27 August 2014

EN04518

**Air quality assessment and review of EIS for the NorthConnex Project**

**Figure 2.1 : Comparison of assumed SRTM data resolutions**

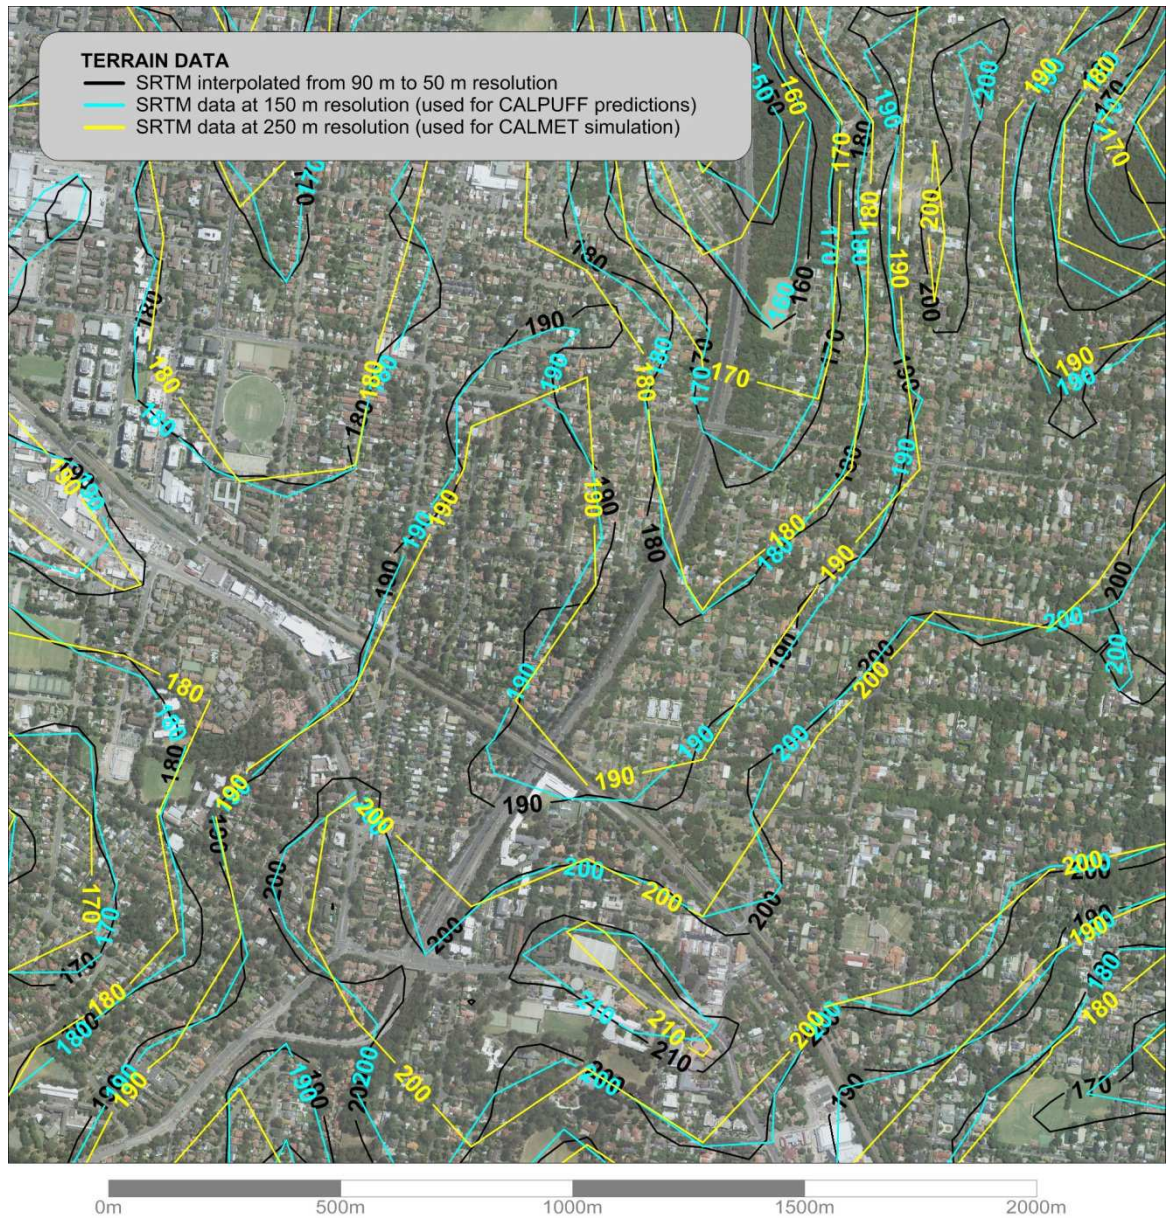
- Issue 2) **Terrain source and resolution:** Figure 2.1 shows the area around the proposed northern ventilation outlet, overlayed with the SRTM terrain data, and including three assumptions on terrain resolution; 50 m, 150 m and 250 m. CALMET has used the SRTM data, gridded at 250 m resolution. From this figure it can be seen that there are differences between the modelled terrain (250 m resolution) and the "actual" terrain (assuming the 50 m resolution is closest to the actual terrain). Differences are in the order of 5 to 10 m depending on the location. The SRTM data also has a limitation in that the radar imaging technique does not always map the true surface, especially when the ground is covered by dense vegetation.

The differences between modelled and actual terrain need to be explained, in terms of whether the simulated meteorological conditions in the vicinity of the northern ventilation outlet will change because of the data source (SRTM) and selected resolution.
